SUBJECT: BRUNSWICK STEAM ELECTRIC PLANT, UNITS 1 AND 2 – ISSUANCE
OF AMENDMENT NOS. 306 AND 334 TO REVISE STANDBY LIQUID
CONTROL SYSTEM BORON SOLUTION STORAGE TANK VOLUME
TECHNICAL SPECIFICATIONS (EPID L-2021-LLA-0022)

SAFETY EVALUATION BY THE OFFICE OF NUCLEAR REACTOR REGULATION

RELATED TO AMENDMENT NOS. 306 AND 334

BRUNSWICK STEAM ELECTRIC PLANT, UNITS 1 AND 2

Figure 3.1.7-1 (page 1 of 1)
Sodium Pentaborate Solution Volume
Versus Concentration Requirements

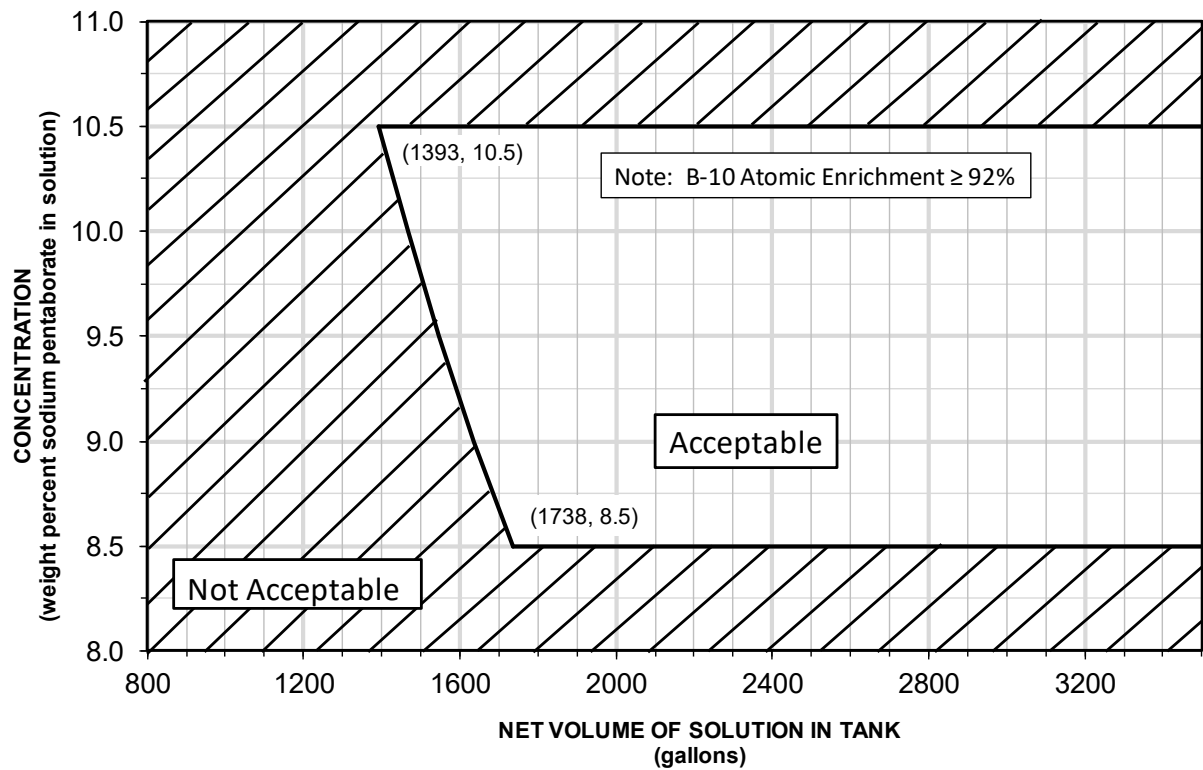
In order to achieve future core reload flexibility for Brunswick and to add margin to the SLC shutdown capability, the licensee plans to increase natural boron concentration from 720 ppm equivalent of natural boron to 925 ppm in the reactor coolant. As a result, the proposed change would increase the minimum boron solution storage tank volume requirements of TS Figure 3.1.7-1 by shifting the left boundary of the "Acceptable" region of TS Figure 3.1.7-1 to the right. The licensee proposes that the existing minimum volume at a concentration of 10.5 weight

percent SPB in solution be increased from 1084 gallons to 1393 gallons. The existing minimum volume at a concentration of 8.5 weight percent SPB in solution would be increased from 1353 gallons to 1738 gallons. The licensee states that no other TS changes are required to support the increase in boron concentration of equivalent natural boron from 720 ppm to 925 ppm.

The NRC staff determined that the proposed TS Figure 3.1.7-1 would increase the required minimum volume of SPB solution in the tank compared to the existing TS Figure 3.1.7-1. As shown in the figure, shifting the left boundary to the right is acceptable because the revised SLC

parameters (i.e., volume of solution in tank and concentration in weight percent of SPB) remain within the existing acceptable region, as established when implementing MELLLA+ (ADAMS Accession No. ML18172A258). In other words, the proposed change is more restrictive because it reduces the acceptable region to operate, and as before, will not allow SLC operation outside of the acceptable region of TS Figure 3.1.7-1. Furthermore, because the proposed amendment to increase the minimum volume of SPB solution in the tank does not change any of the variables in the boron equivalency equation (i.e., flow rate, vessel water mass, weight percent SPB in solution and B-10 enrichment), the requirements of 10 CFR 50.62(c)(4) continue to be met with the same margin that is currently approved by the NRC.
